Restricted substances according to S 132030-1	
Proposal supplier drawing	
Brake component	
SC	Classification of characteristics according to S 102012-1
material 16MnCr5 K+GKZ+LG acc. to S 130284	SC

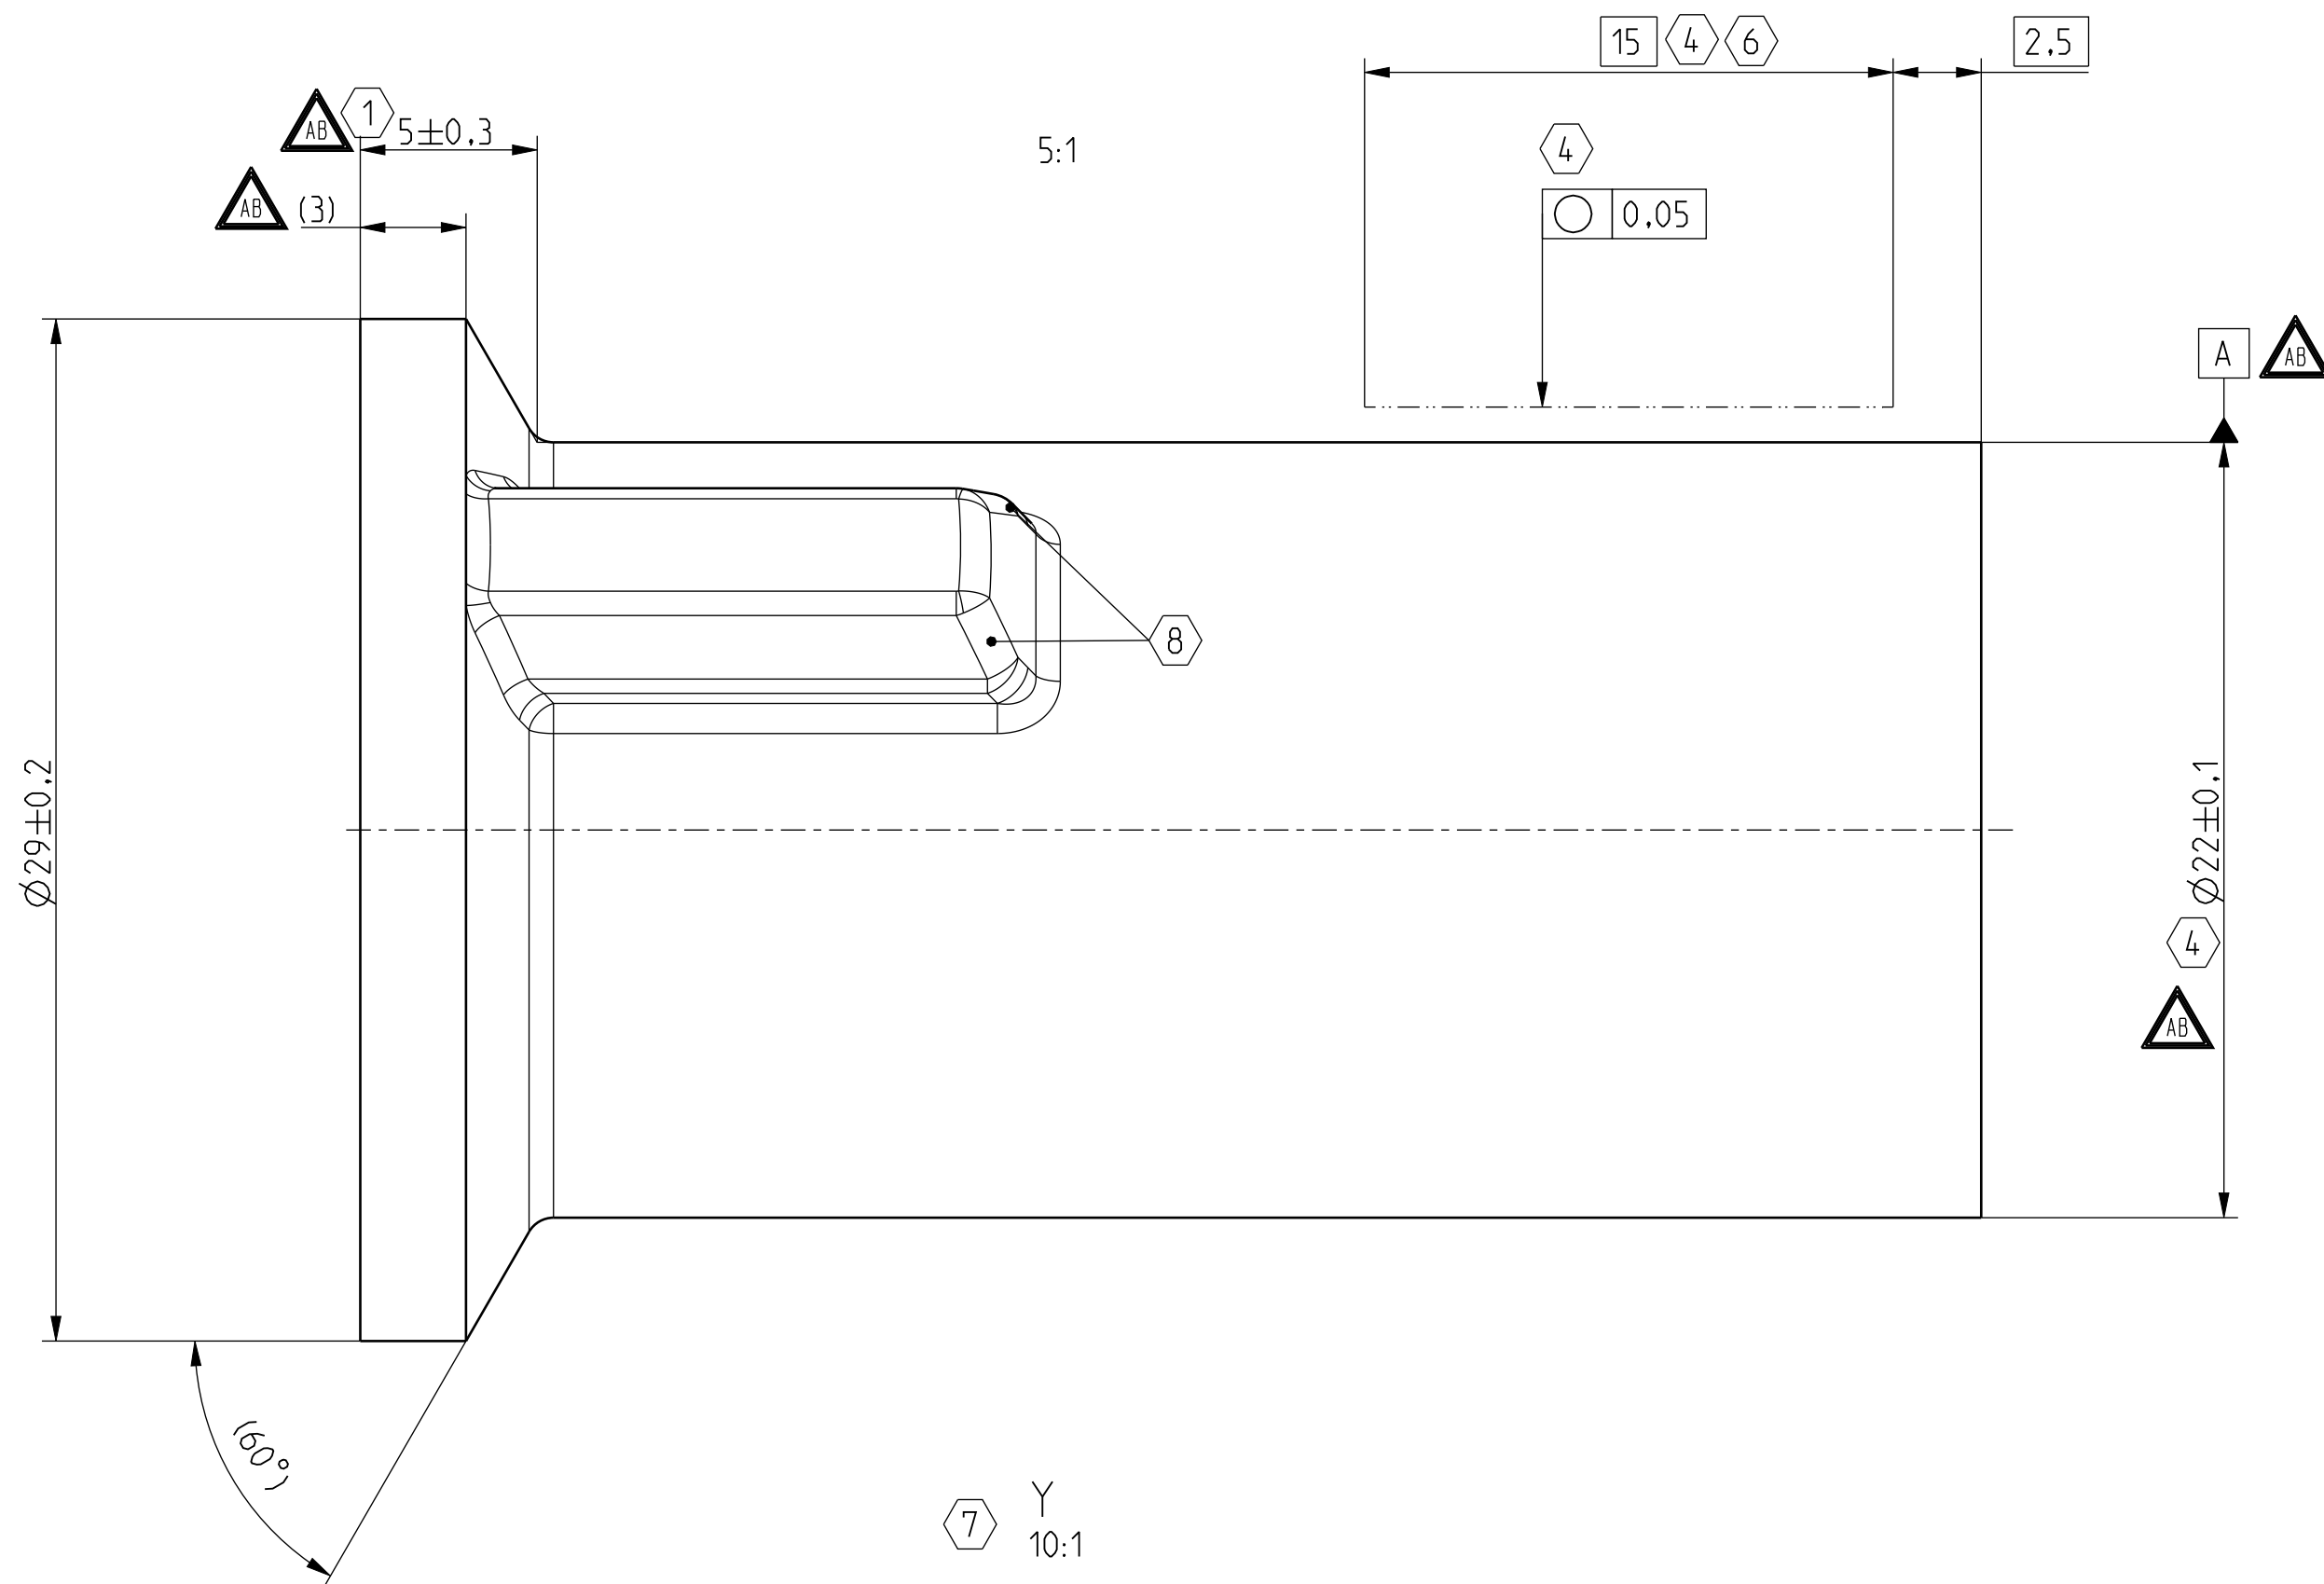
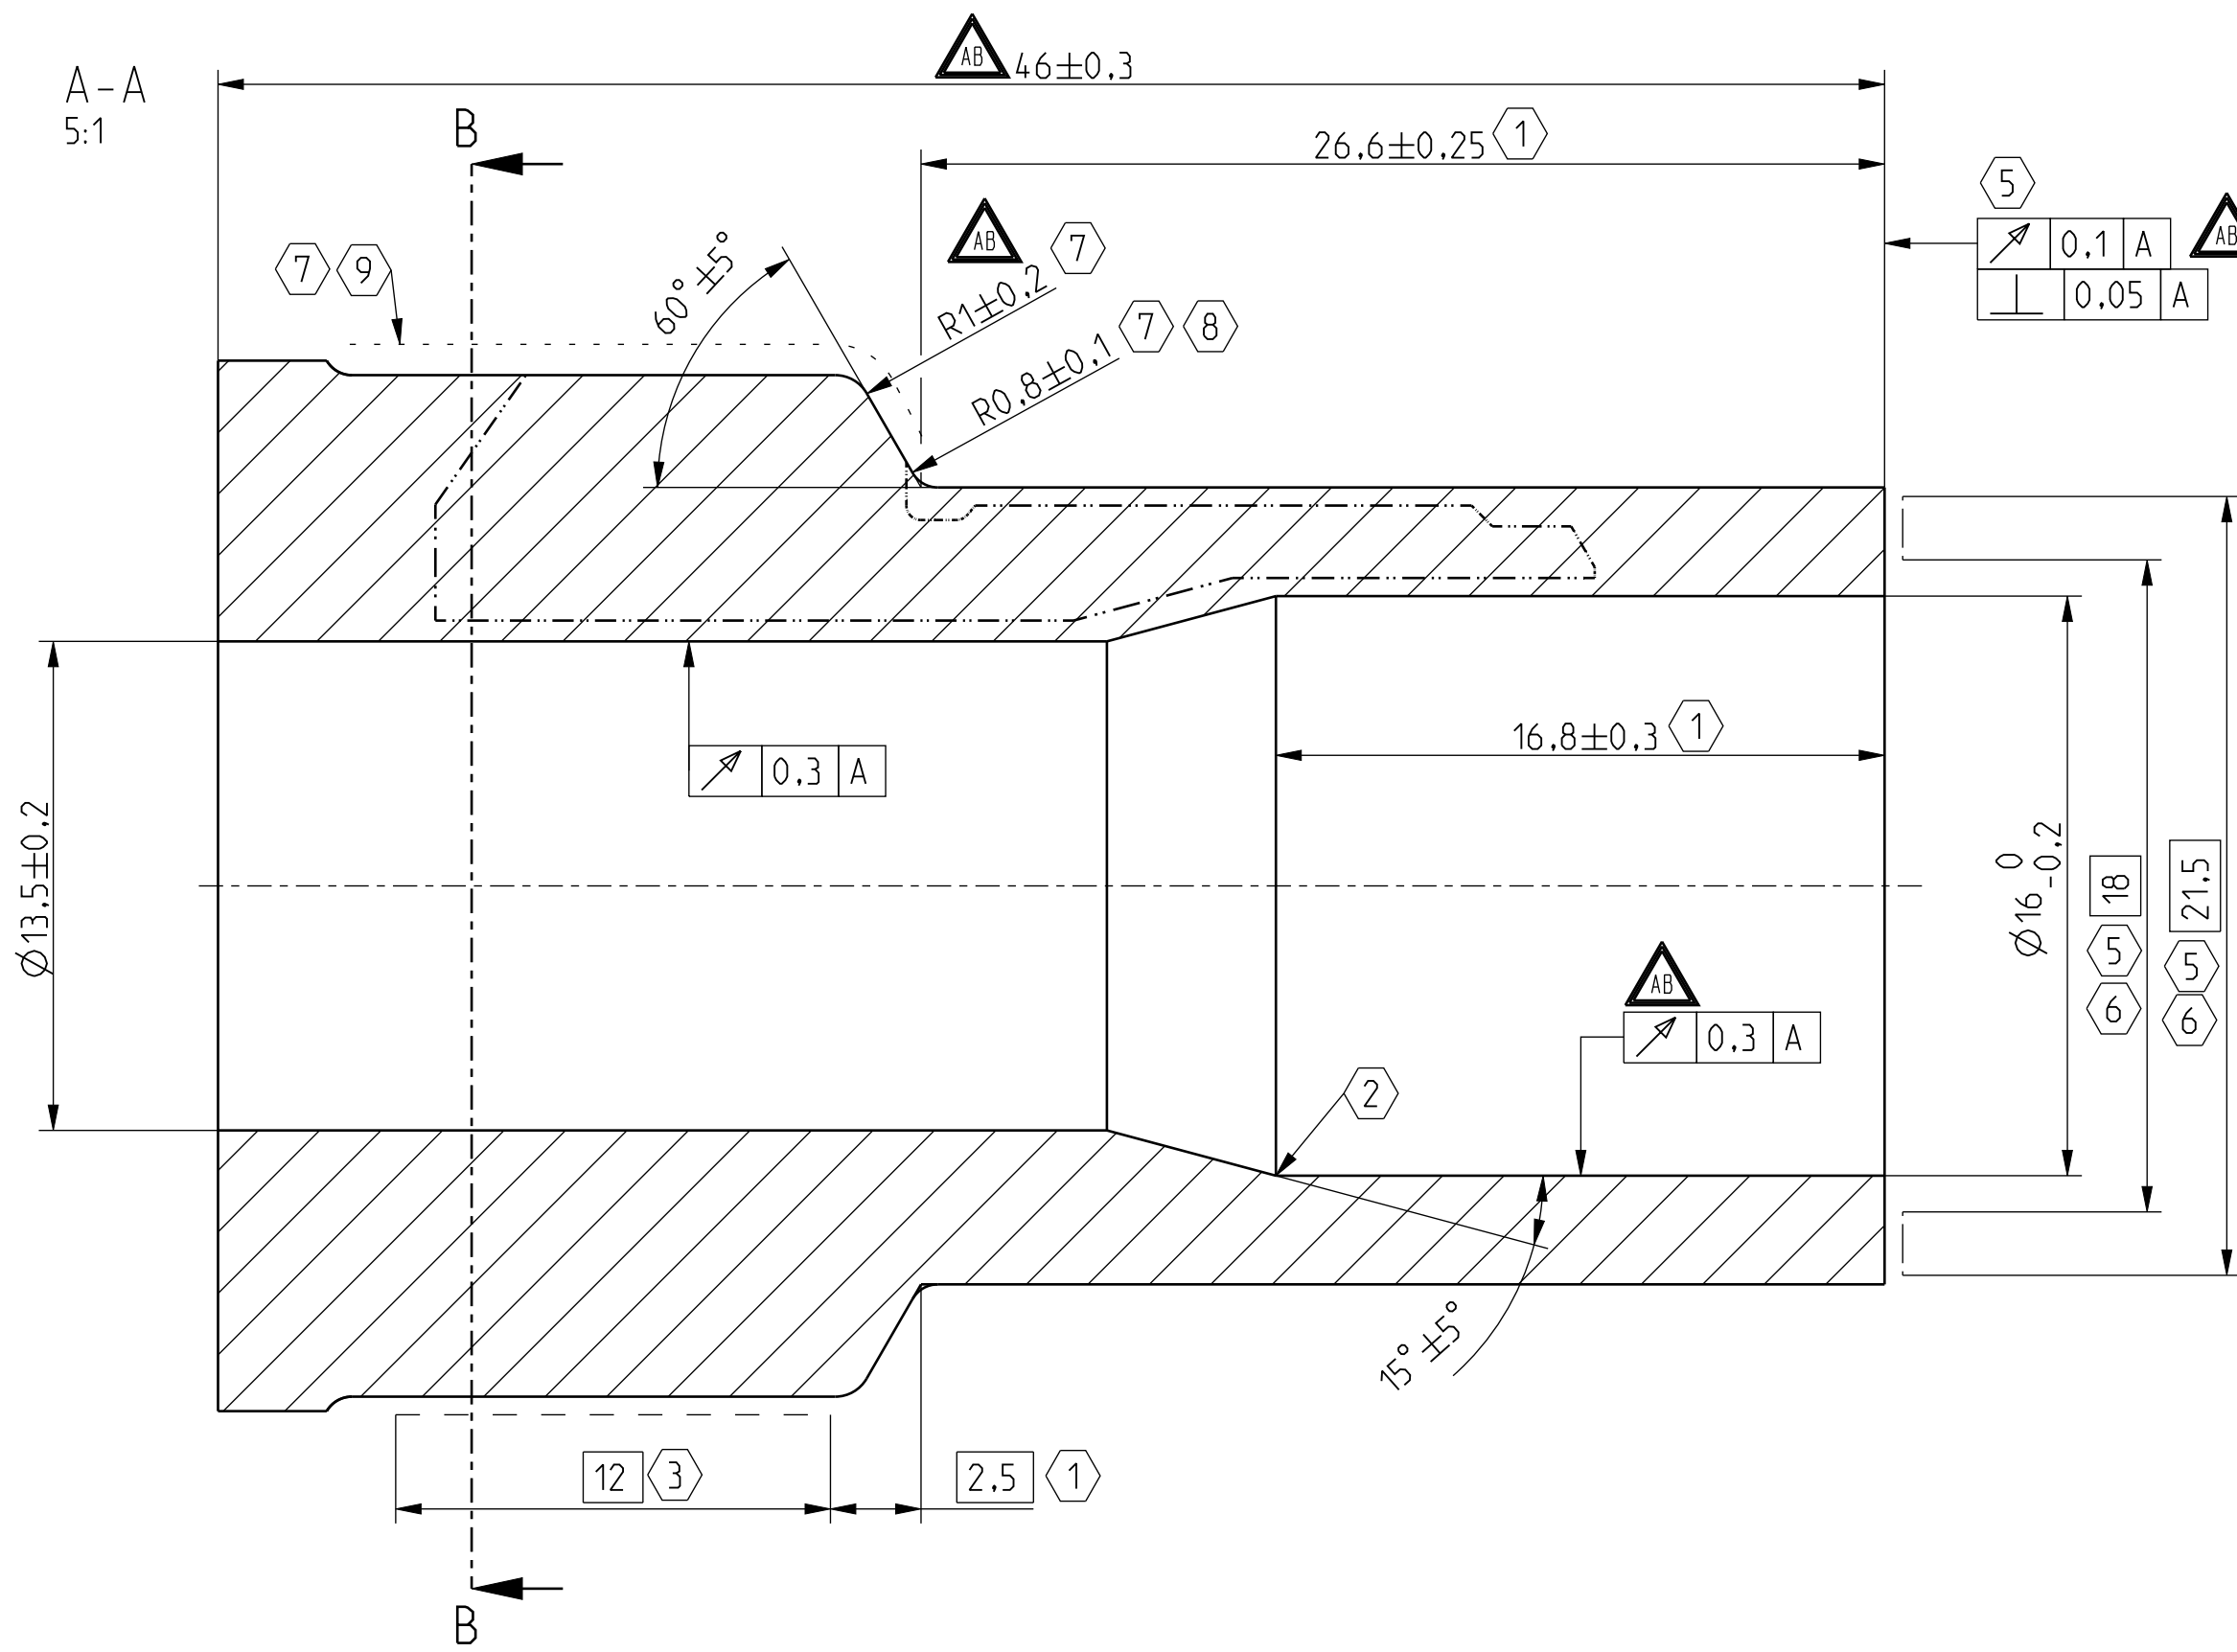
Add. Data / 추가정보			
Item / 자재코드		Ref. No.	Designation / 명칭번호
Tolerancing ISO 8015 제도통칙			
Version AB	Date 2026-05-07	Modification description / 개정기사 - Tolerances were increased for production	
Prev ver 구버전 AA	Modif. No. 개정번호 C218747	- Change : ø22±0.15 → ø22±0.1 for clamping, Width : 46.5 → 46	
Scale 척도 1:1		Description / 분류 Ball screw nut	Prep. by / 설계자 Ji Eun Jo
General tolerances 표기외공차 -		Additional description / 상세분류	Checked by / 검토자 Yong Su Kim
Mass approx. / 중량 약 89.91 g		Mater., semi-finished prod. / 반제품	
Sheet 페이지 1 / 1	Size 크기 A1	Proposal supplier drawing 공급업체 제안 도면	Document / 도면번호 EDS F-627894.15-0029-C04 X30
